NUMBER: 14-003-12

GROUP: Fuel System

Fuel Spit Back During Refueling (X32 Warranty Extension Unlimited Time And Mileage)

2007 - 2008 (JK) Wrangler

Fig. 1 Fuel Line

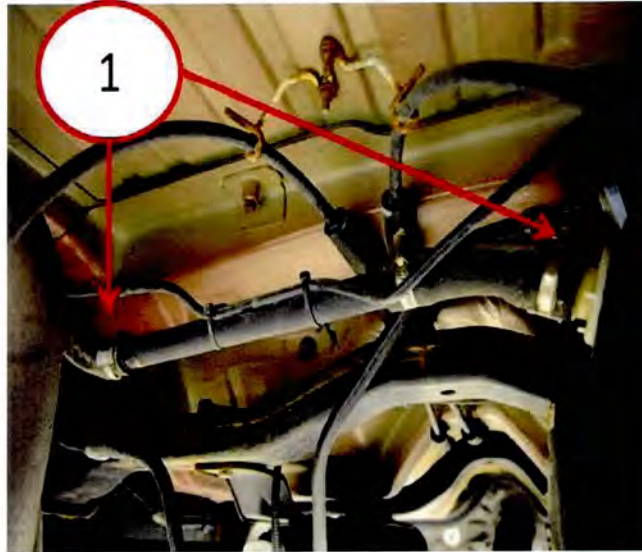
This bulletin involves replacing the fuel tube at the fuel tank. This new fuel tube has a check valve.

1. Open Hood.
2. Disconnect and isolate negative battery cable.
3. Remove fuel cap.
4. Hoist vehicle.
5. Cut the tie straps holding the recovery line to the fuel tube.
6. Remove the fuel tube and discard(Fig. 1).

7. Install the fuel tube (CNNX321ac) and torque clamps to 3 N·m (30 in. lbs).
8. Tie strap (06016076) recovery line to fuel tube in tow places (Fig. 1).
